Pioneer Square Preservation Board

Staff REPORT

The Lofts

Replace windows of the east and west facades with aluminum windows and replace the storefronts on the west façade with an aluminum storefront system.

AST ELEVATION

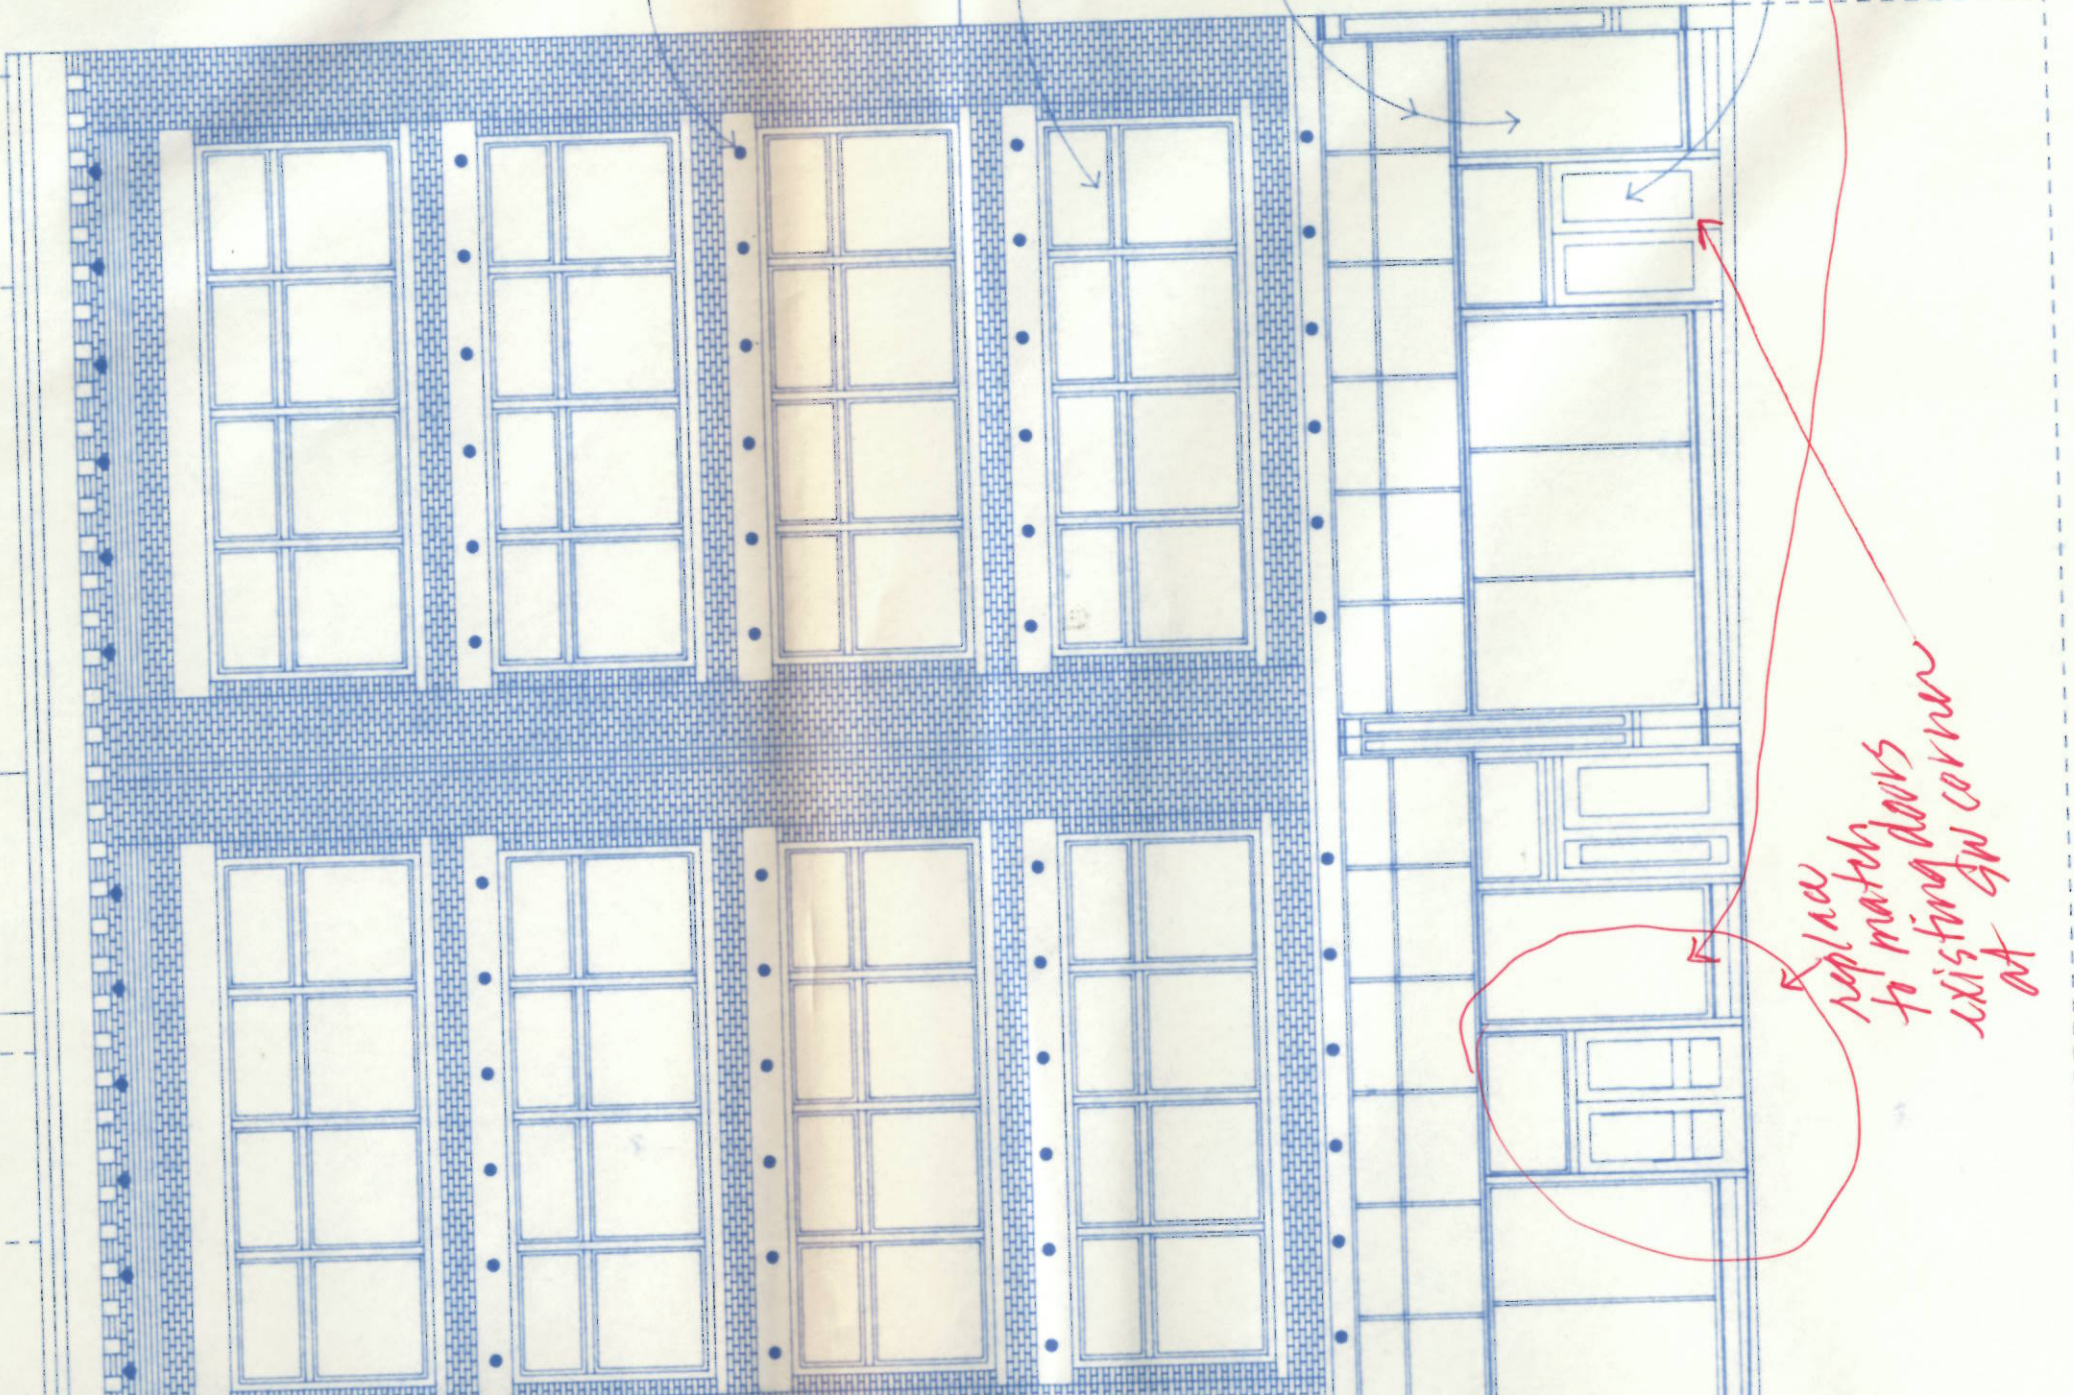
EXIST. WINDOWS TO REMAIN - REGLAZE EXIST. WINDOWS W/ DOUBLE GLAZED. REPLACE W/ ROTTEN FRAME AS NEEDED W/ MATERIALS & PROFILES TO MATCH ORIGINAL CONDITIONS

EXIST. STOREFRONTS TO REMAIN - REGLAZE EXIST. WINDOWS W/ DOUBLE GLAZED. REPLACE ROTTEN FRAME AS NEEDED W/ MATERIALS & PROFILES TO MATCH ORIGINAL CONDITIONS

REPLACE EXIST. WD. & GLASS DOORS (2) W/ DBL. GLAZED WD. & GLASS DOORS. DOOR LOCATION WITHIN THE EXIST. STOREFRONT SYSTEM TO REMAIN, HOWEVER, RECESS DOORS TO COMPLY W/ SEATTLE BLDG. CODE REQUIREMENT THAT DOORS NOT OPEN OVER PUBLIC RIGHT OF WAY

replace rotten doors to match doors existing @ corner of

A3.1

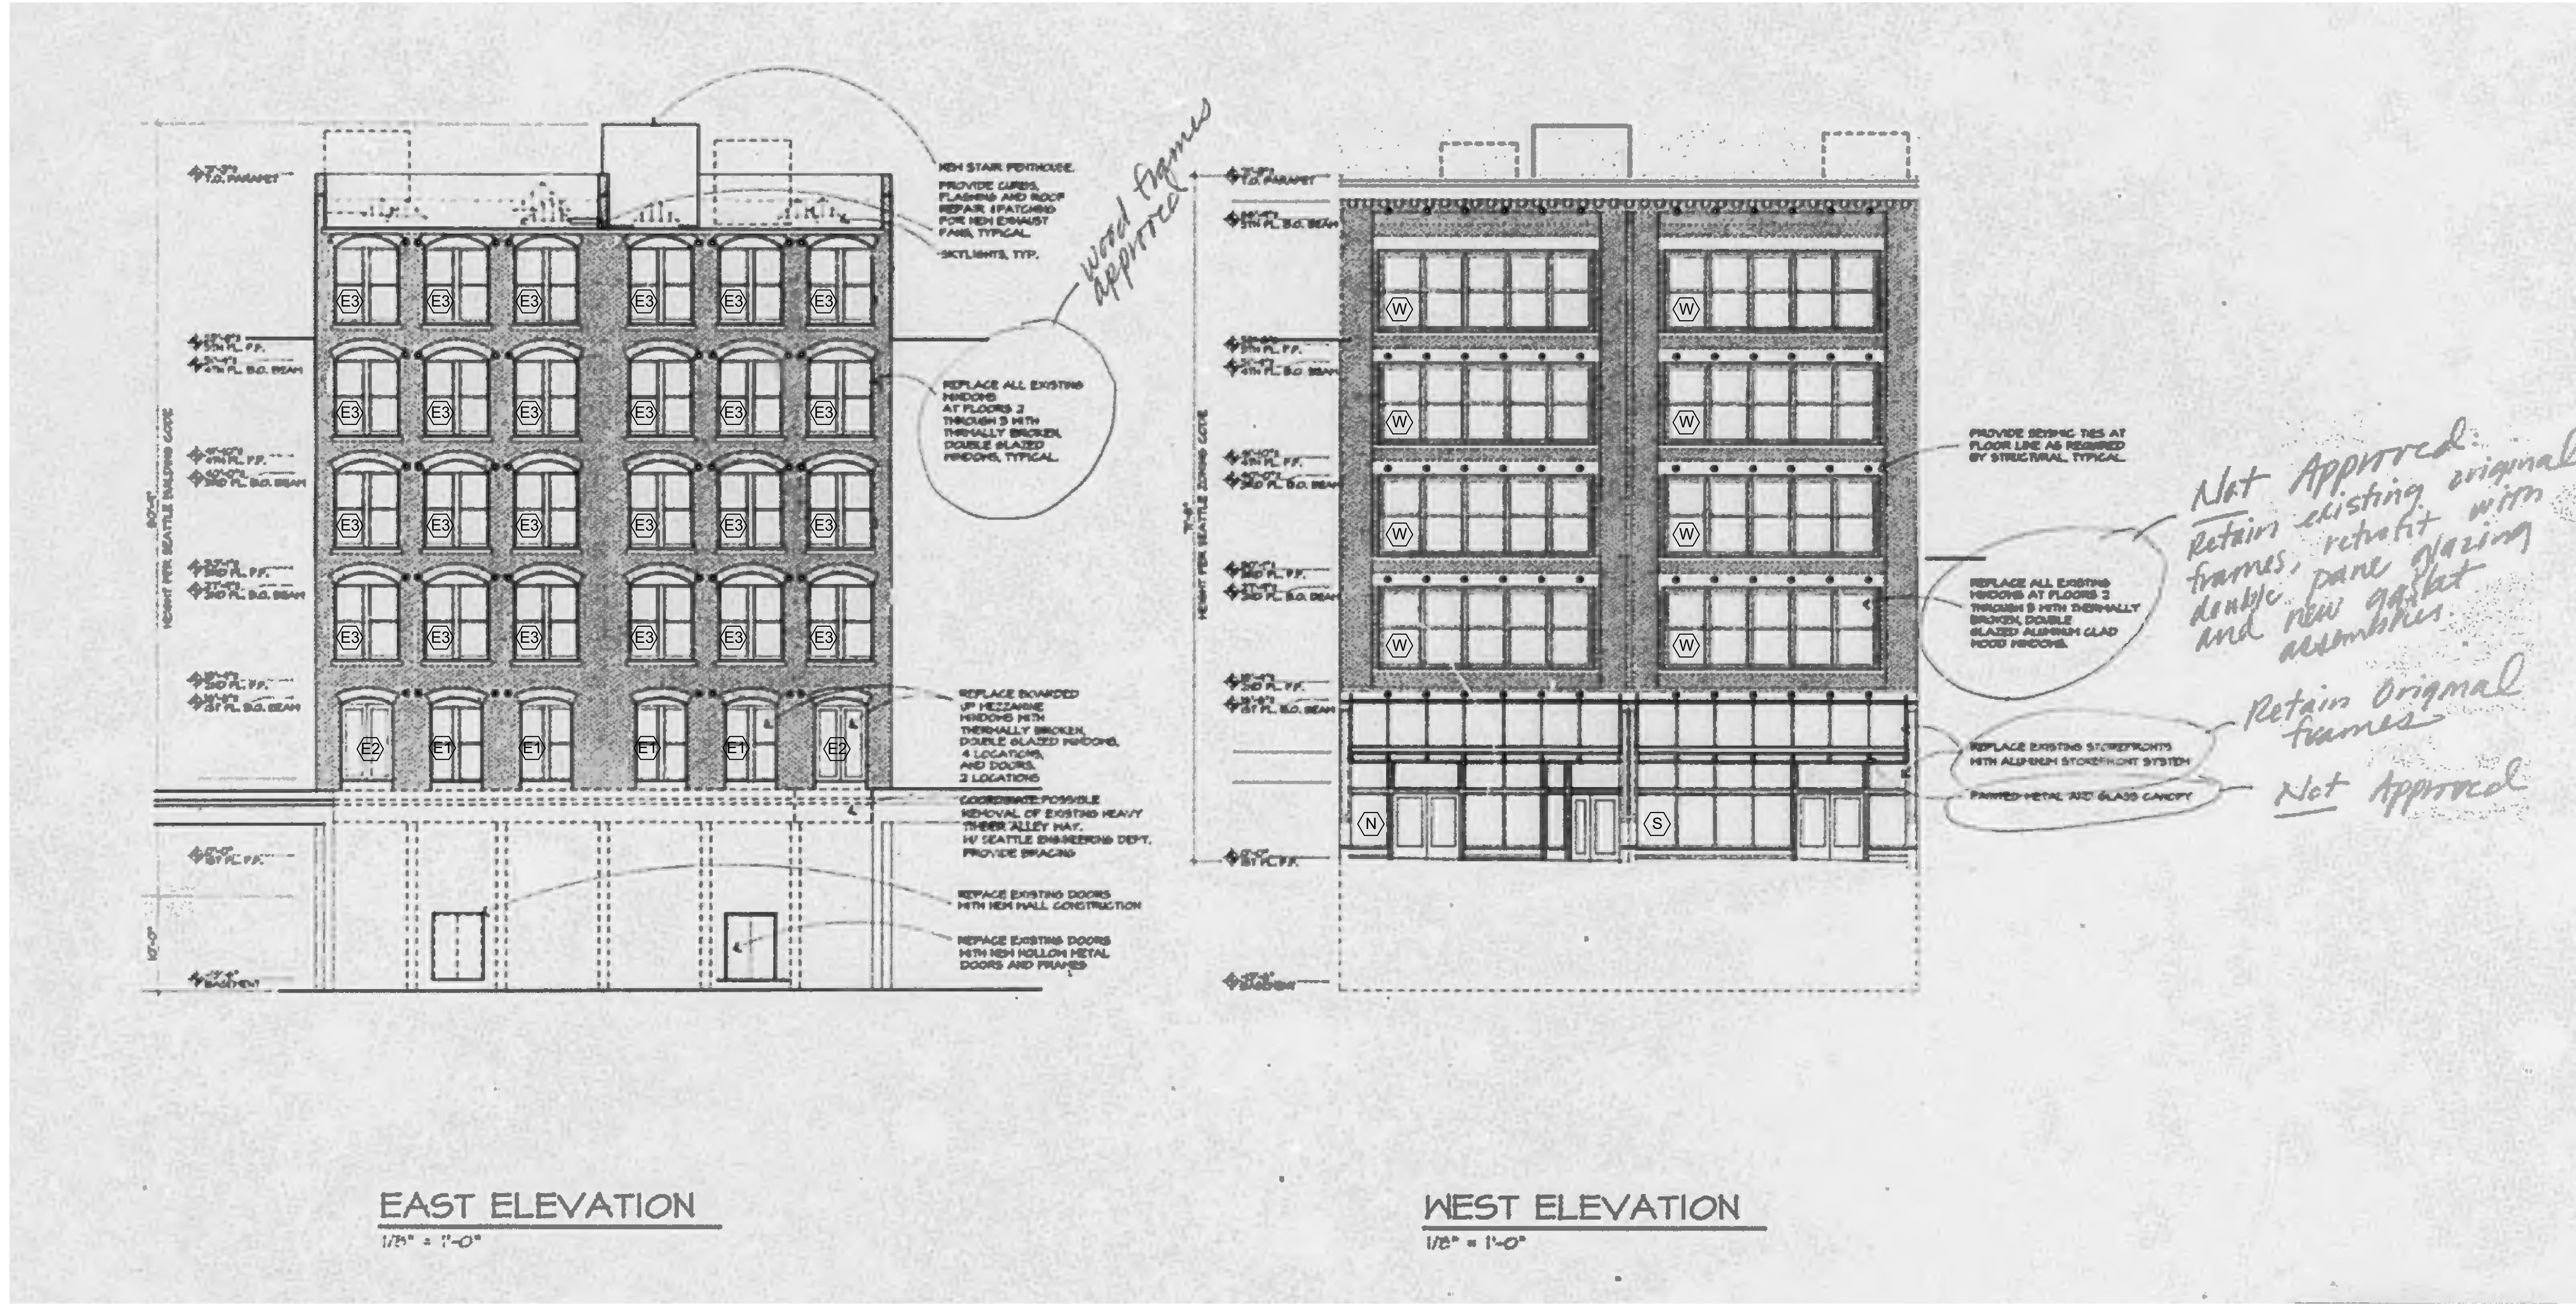
The applicant has amended their application to partially salvage this decorative trim piece to attach it to a metal clad HSS beam. A profile detail is provided but it unclear why only some it will be salvaged and the extent that it will be reinstalled. This should be clarified.

The first question is if the Board should consider is if previous repairs have altered the storefront to the point of that it is not the same character or has lost significant features? If the Board finds that the display glass and entries has been highly altered, do they find that the transom windows appear intact and should be retained? The second question is if the proposed material and design of the aluminum storefront is appropriate. Standard 6 says "Deteriorated historic features will be repaired rather than replaced. Where the severity of deterioration requires replacement of a distinctive feature, the new feature will match the old in design, color, texture and, where possible, materials." Does the Board find that new storefront matches in profile and dimensions, and texture and material based on photos and remaining material?

I recommend denial of a Certificate of Approval for replacing the wood storefronts. Storefronts are the most prominent and important feature in defining the character of a historic commercial building and a feature that is experienced closely by pedestrians. The storefronts appear to have had little alteration limited changing two windows to doors and a door to a window and recessing the location of entries

according to photo documentation. Information provided by the applicant only show that one location of rot exists in the existing storefront and the storefront appears to be repairable through caulking, painting and patching the one location of rot which does not require wholesale replacement of the storefront. The existing storefront is already retrofitted with double pane glass. The transom windows appear to be original and unaltered according to the photo provided and should be retained. The existing storefront though altered and existing transom windows which appear original, are still compatible with the building design and original storefront in materials, proportions and profile once repaired and contributes to the integrity of the building as a whole. The character of the of the proposed aluminum material, texture and profile of the windows is not consistent with material, texture and profile of the wood storefront and is not compatible as a replacement compared to retaining the existing storefront. *(list any other reason that the Board discusses.)*
